SERVICE BULLETIN

Service Hints and Information on the Model 1140

MULTI-SYNC

Adjustment

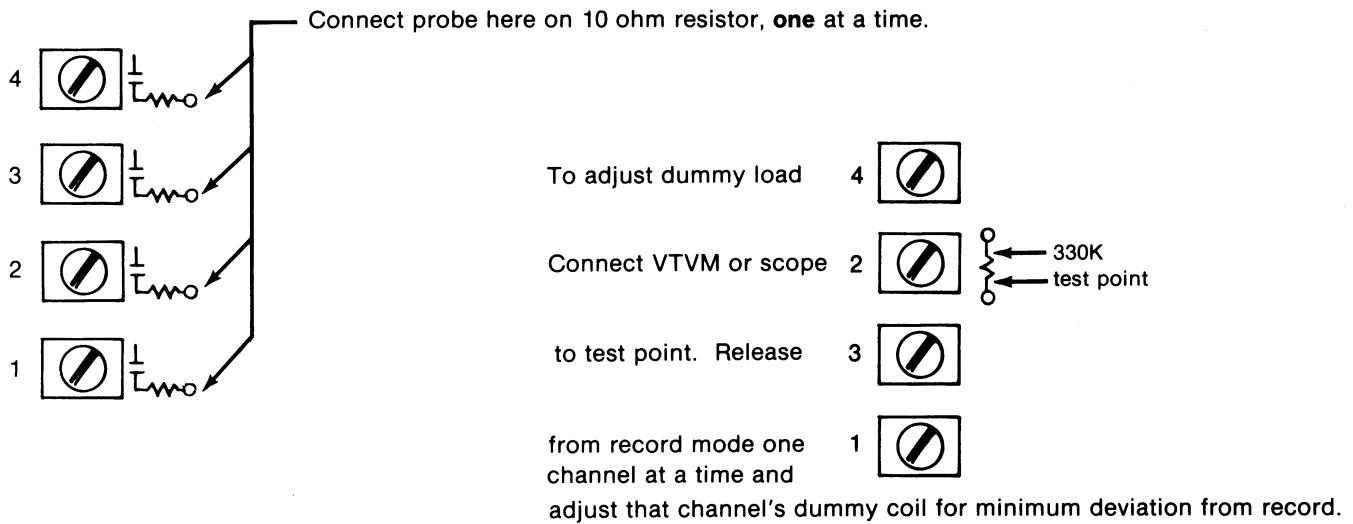
1. Load unit with tape, bias in fixed mode, unit in record, pause on, multi-sync off, all channels in record.
2. With VTVM or scope, adjust bias trap coils for minimum reading (see below).

3. Check playback bias traps located in upper deck.
